REMARKS

Claims 1-12 are pending in the Application.

I. OBJECTIONS TO THE DRAWINGS

FIG. 4B

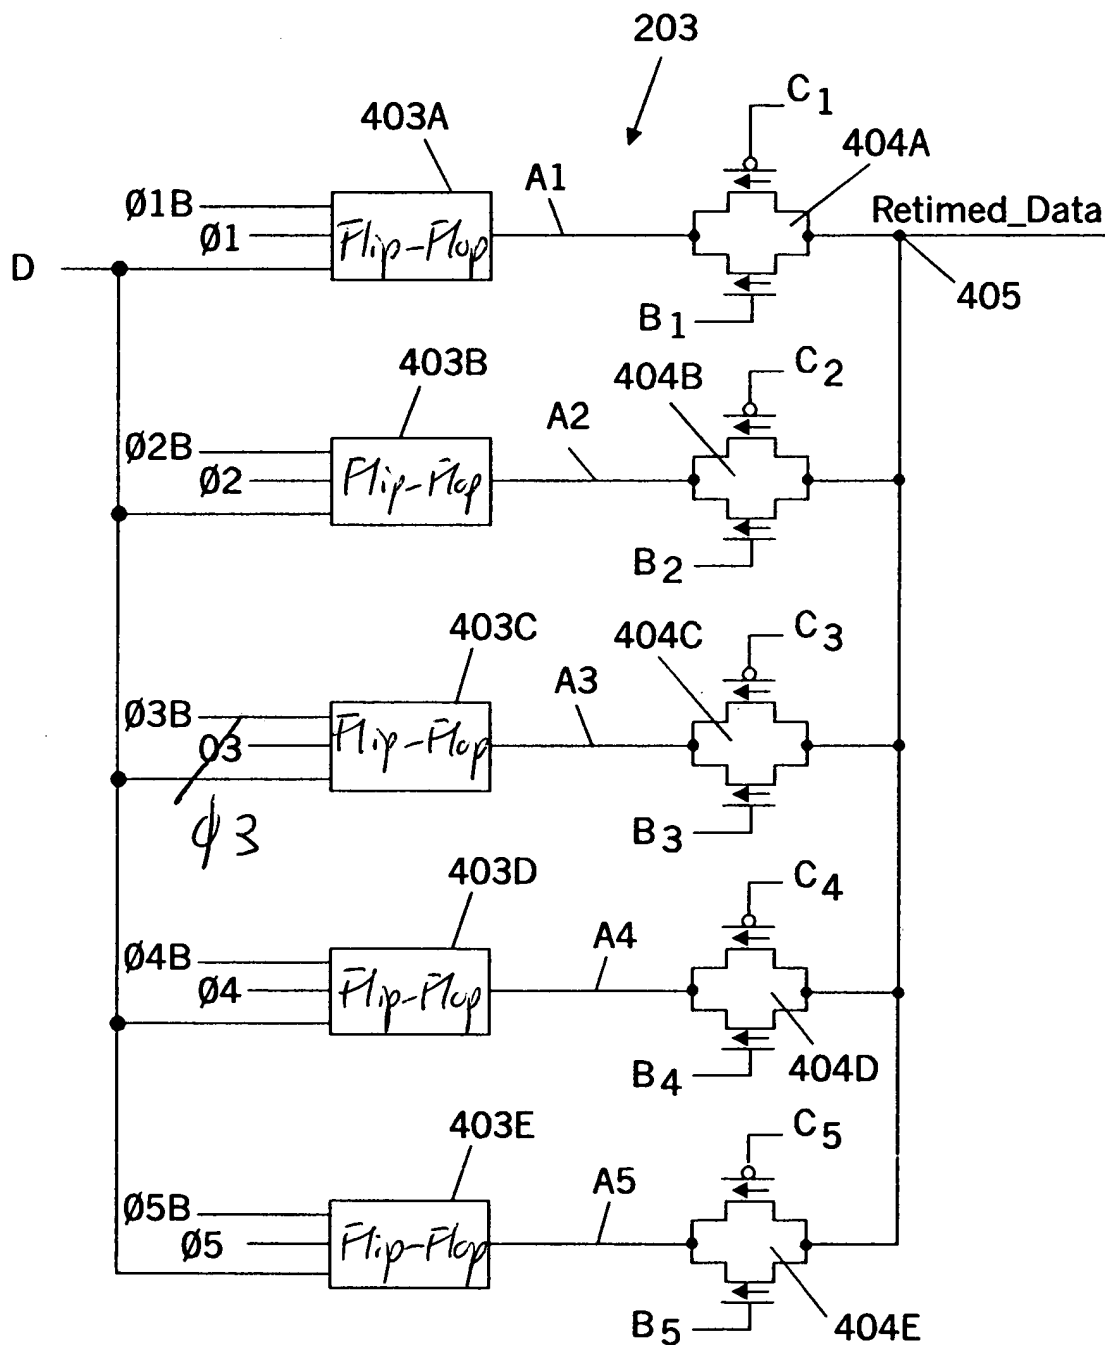
The Examiner has objected to Figure 4B because the reference sign "03" should be "Ø3" as well as missing a label for elements 403A-E. The Examiner has further objected to Figure 4A since elements 401A-E do not contain a label. Applicant has amended Figure 4B to include the appropriate reference sign "Ø3" as well as added the label of "Flip-Flop" to elements 403A-E, as indicated above. Applicant, however, does not believe that a label to elements 401A-E is warranted as a person of ordinary skill in the art understands that the symbols of elements 401A-E are NAND gates.

Applicant has replaced the incorrect label "03" with the correct label "Ø3" in Figure 4B. Applicant has further added the label of "Flip-Flop" to elements 403A-E in Figure 4B. Applicant has attached an annotated sheet of Figure 4B indicating the replacement of the label "03" with the label "Ø3" as well as the addition of the label "Flip-Flop" to elements 403A-E. Applicant has further attached a replacement sheet for Figure 4B incorporating the changes mentioned above.
